Central Planning Authority

Agenda for a meeting of the Central Planning Authority to be held on **March 30, 2022 at 10:00am in Conference Room 1038, 1st Floor, Government Administration Building, and Elgin Avenue.**

CPA/09/22

Figure 1: DoE habitat map overlaid on LIS aerial imagery.

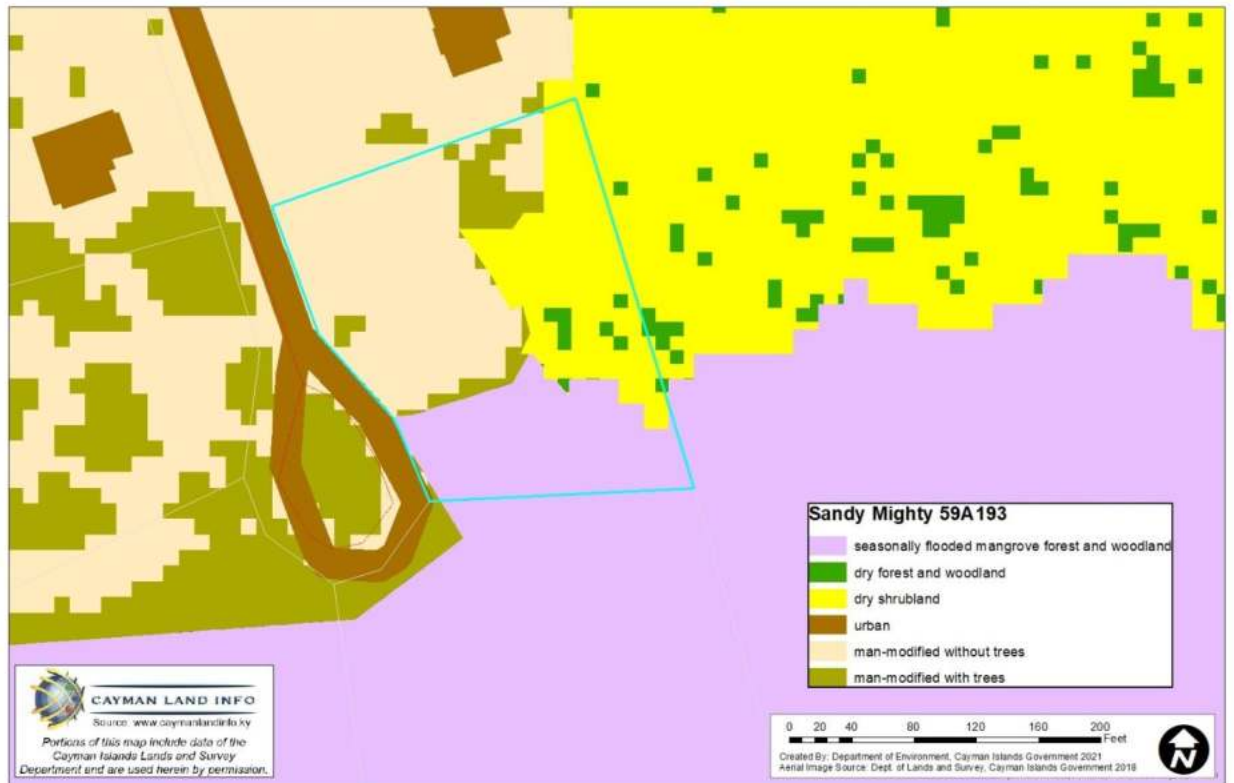
The DoE's habitat layer showed that the application site consisted of a mixture of primary dry shrubland, seasonally flooded mangrove and some man-modified areas with regrowth as shown in Figure 1 below. A review of Lands and Survey imagery indicates that some of the primary dry shrubland habitat has previously been cleared (see Figure 2). The site is low-lying does not appear to be suitable for farming as it would require a substantial amount of fill.

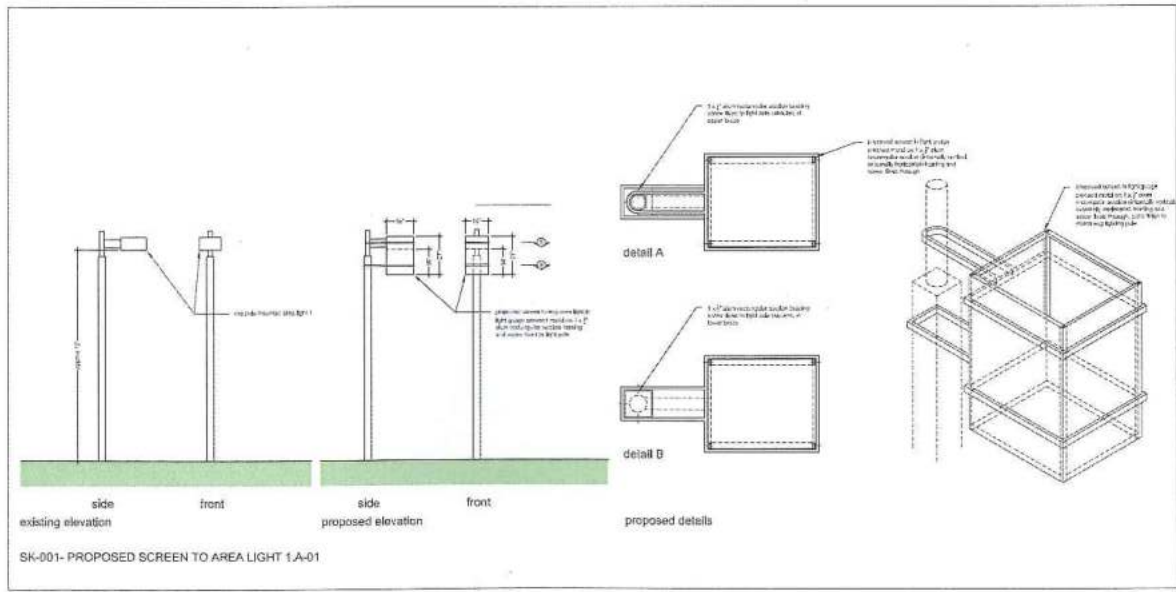
- SOFT MOUNTED DIRECTIONAL- TYPE C- (2.C-05)
Existing lamp to have bulb replaced to provide minimum 630nm wavelength light.
Lamps to be directed landward and downward.

- TREE MOUNTED DIRECTIONAL- TYPE C- (2.C-06)
Existing tree mounted lighting to have bulb replaced with LEDs to provide minimum 630nm wavelength light.
All light fixtures to be directed landward.

- POLE MOUNTED DIRECTIONAL- TYPE D (1.D-02 & 3.D-01)
Existing lamp to have bulb replaced to provide minimum 630nm wavelength light.
All light fixtures to be directed away from the beach, facing landward and downward.
